**Dillon & Savage Architects**  
40 Quinton Rd, Manly, 2095  
Phone: (02) 9977 3714 Fax: (02) 9977 8215  
email: dsarchs@bigpond.net.au

Project  
Proposed Child Care Centre  
Leichhardt Park

Drawing  
**ROOF PLAN**

Drawing No. <b>103 131 TD06</b>	
Issue <b>F</b>	Date <b>March 2015</b>
Scale <b>1:100 @A1</b>	Drawn <input type="checkbox"/> Checked <input type="checkbox"/>

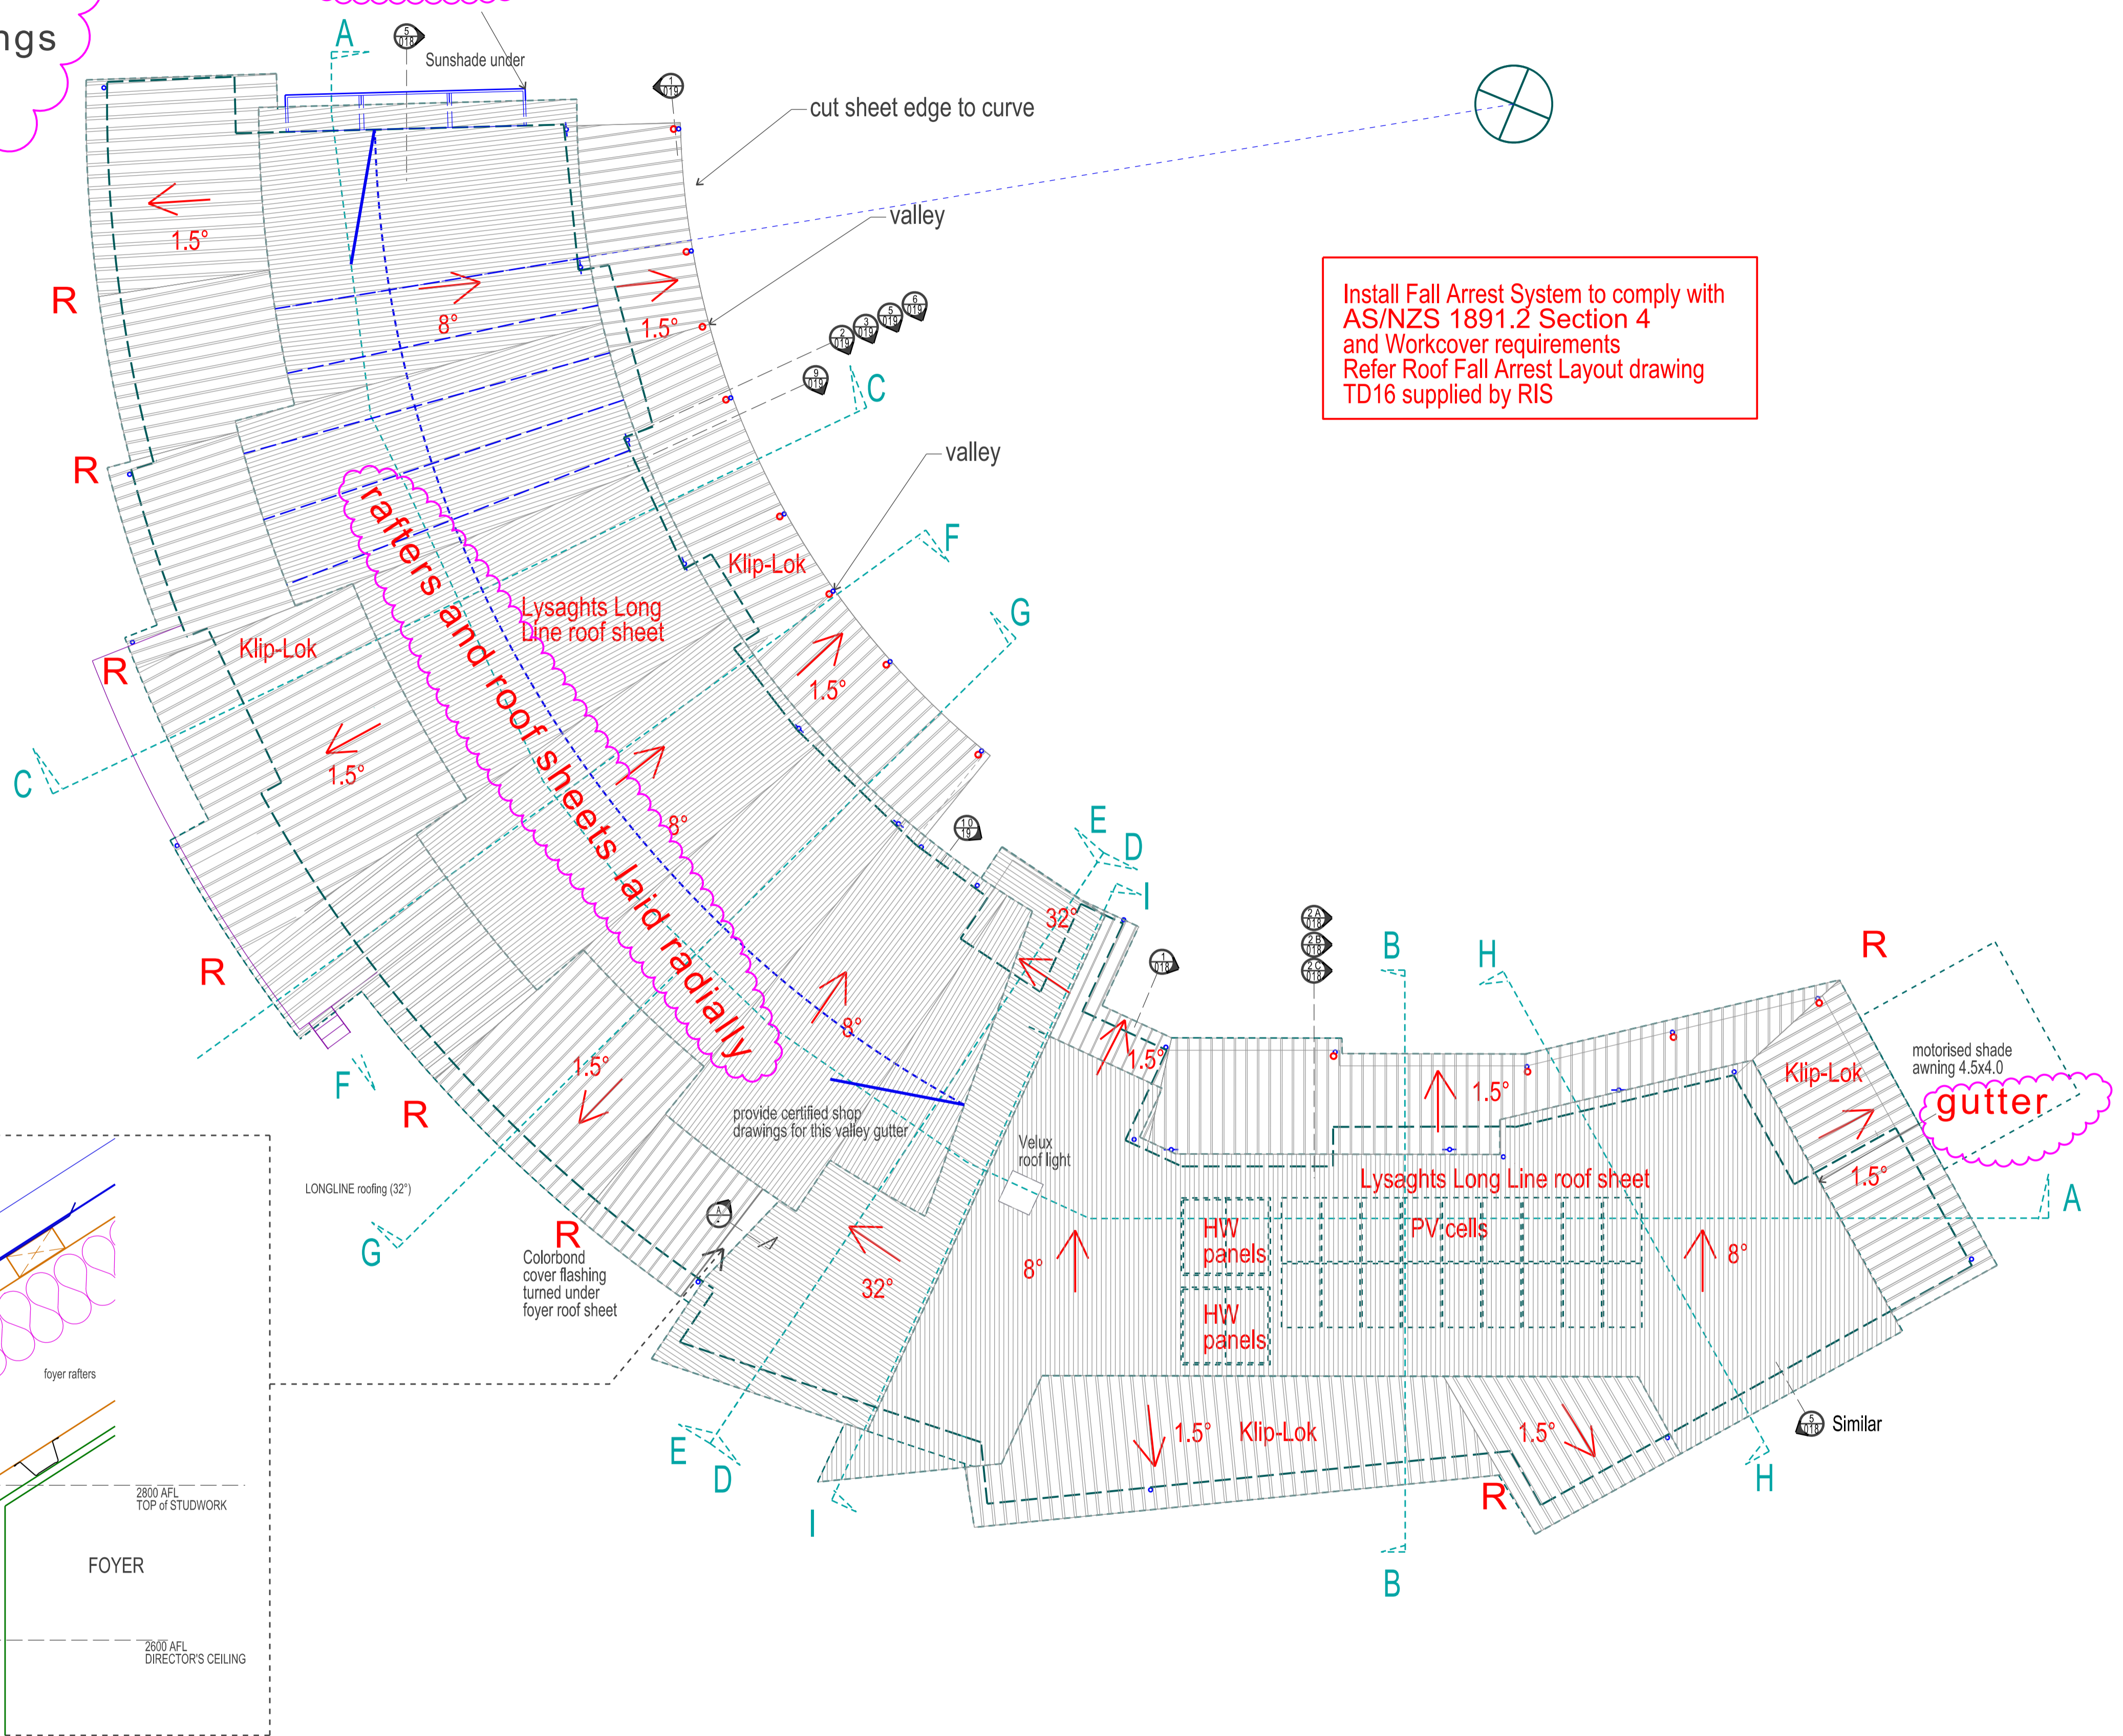
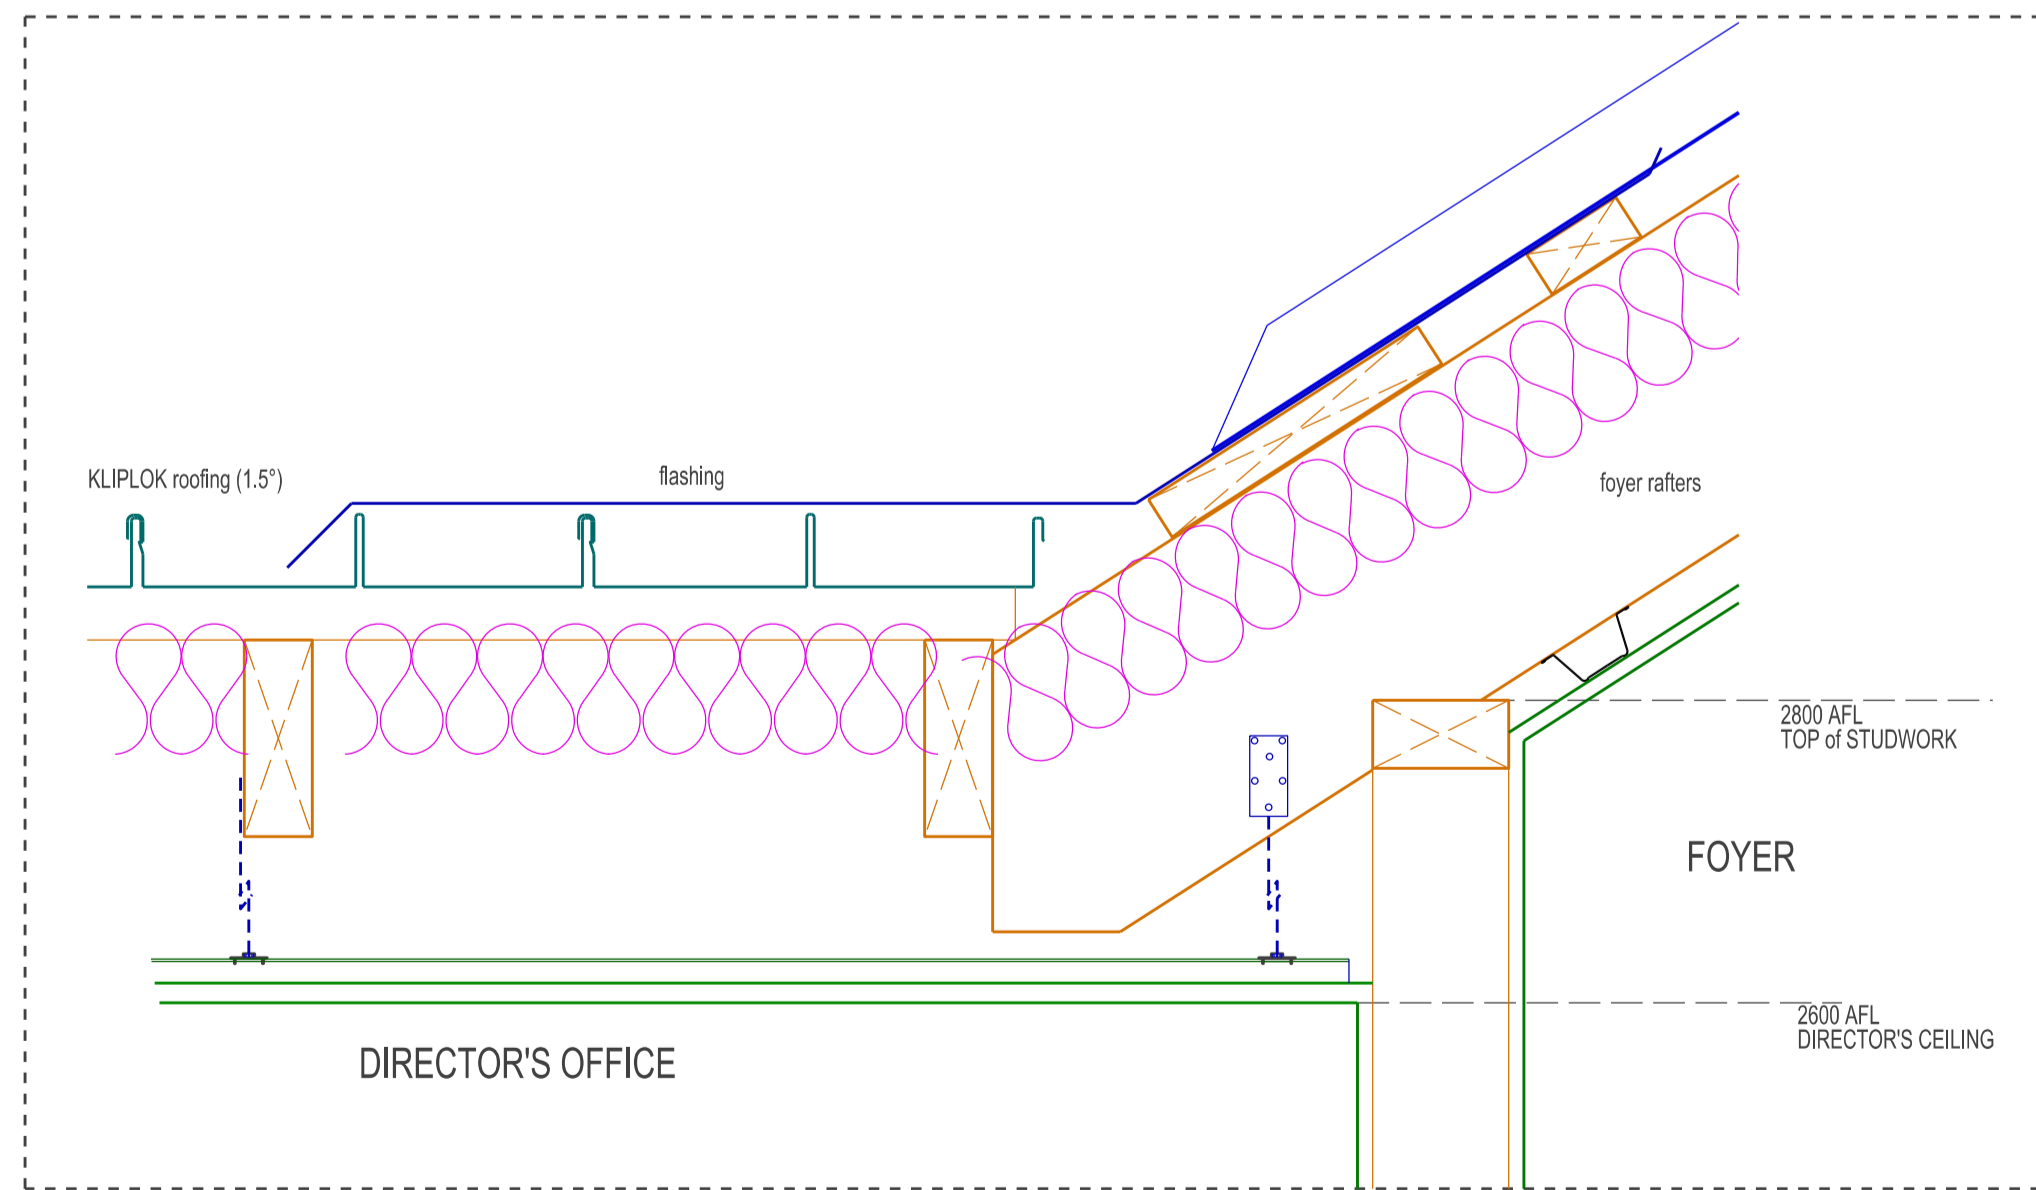
F	13/5/16	Notes added regarding curved roof installation and gutters at building ends.
E	10/5/16	Veranda columns and downpipes locations amended.
D	5/3/16	Veranda columns and downpipes locations amended.
C	16/7/15	CONSTRUCTION ISSUE
B	19/4/15	Issued for tender
A	23/3/15	Issued for pre-tender estimate
Date		Amendment

The 1.5° pitch of the lower roofs means that the sheets can be laid straight and the edge cut to the curve

no gutter
